**IN THE DRAWINGS**

**REMARKS**

Docket No.: 100807-00054 (FUSA 19.314)

FIG. 8

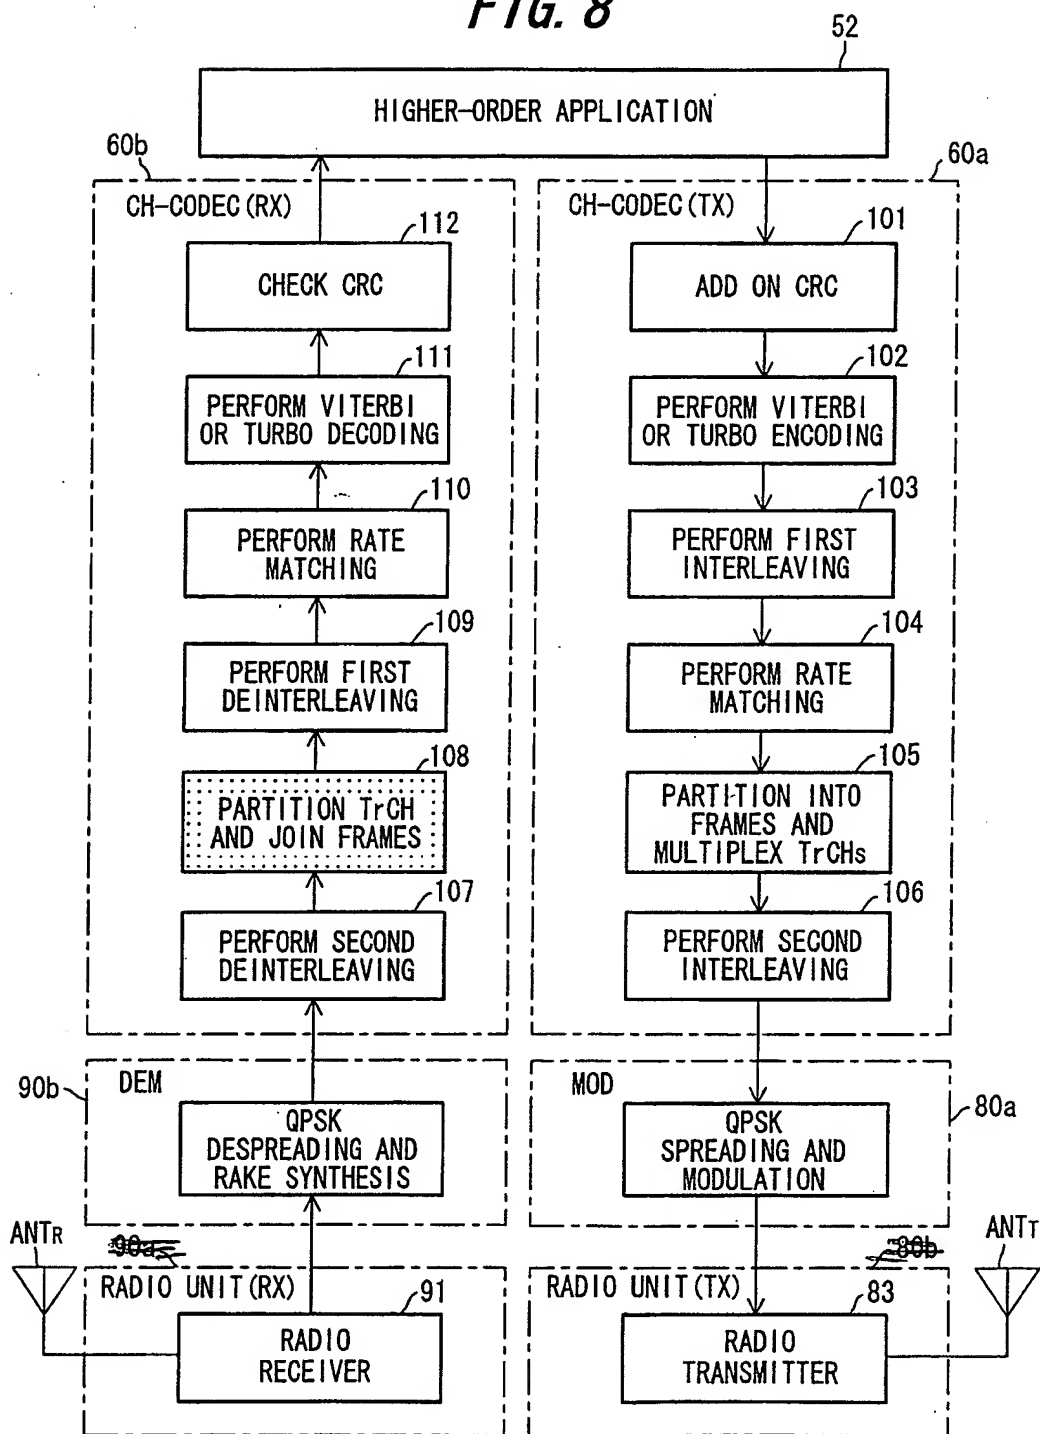
The Examiner objected to the drawings under 37 CFR 1.84(p)(4) for having separate designations "90a" and "91" for "Radio Receiver," and designations "80b" and "83" for "Radio Transmitter." Applicant amends Fig. 8 and its corresponding description in the specification to remove designations "90a" and "80b."

Applicant encloses Annotated Sheets of Figs. 8 and 9 illustrating amendments to these figures for clarification. Applicant also encloses Replacement Sheets for Figs. 8 and 9 reflecting the amendments. Applicant further encloses Replacement Sheets for Figs. 18-28. Please add the caption "Prior Art" to Figs. 18-28.
